SOLO EVENTS BOARD

SOLO EVENTS BOARD | November 24, 2014

Figure 1 – Location of the Controlled Area

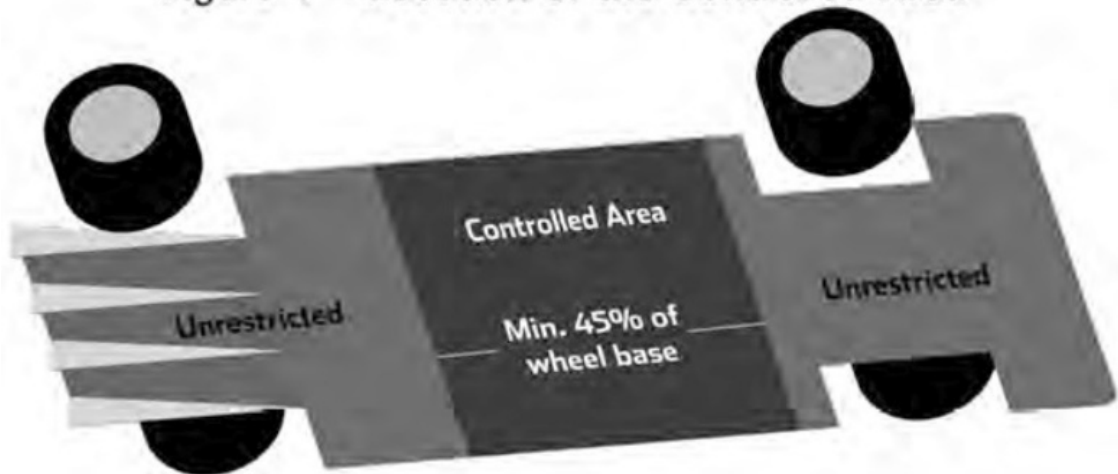
a. **For the full width of the body the floor pan will be a minimum of 45% of the wheelbase; the lower surface (surface licked by the air stream) shall not exceed +/-2.54 cm (1 inch) deviation in any longitudinal section through the plane forming the bottom of the tub or chassis floor. The 45% minimum (of the wheelbase) dimension is measured from the point that the surface meets the full width of the body (behind the front wheel or in front of the rear wheel). (This is not to be interpreted as requiring a floor pan beneath the motor, transaxle, transmission, or final drive housing.) See Figure 1.**

b. **No aerodynamic devices (e.g. "skirts," body sides, etc.) may extend more than 1cm (0.394 inches) below this lower surface anywhere on the car to the rear of the front axle. Seat bucket or other protrusions shall not circumvent this rule.**

Figure 1 – Location of the Controlled Area

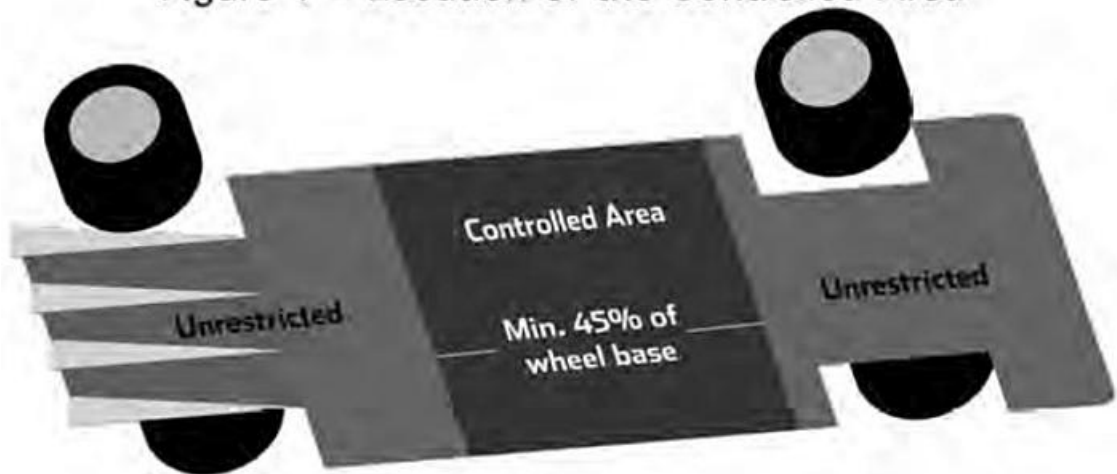
a. For the full width of the body the floor pan will be a minimum of 45% of the wheelbase; the lower surface (surface licked by the air stream) shall not exceed +/-2.54 cm (1 inch) deviation in any longitudinal section through the plane forming the bottom of the tub or chassis floor. The 45% minimum (of the wheelbase) dimension is measured from the point that the surface meets the full width of the body (behind the front wheel or in front of the rear wheel). (This is not to be interpreted as requiring a floor pan beneath the motor, transaxle, transmission, or final drive housing.) See Figure 1.

b. No aerodynamic devices (e.g. "skirts," body sides, etc.) may extend more than 1cm (0.394 inches) below this lower surface anywhere on the car to the rear of the front axle. Seat bucket or other protrusions shall not circumvent this rule.
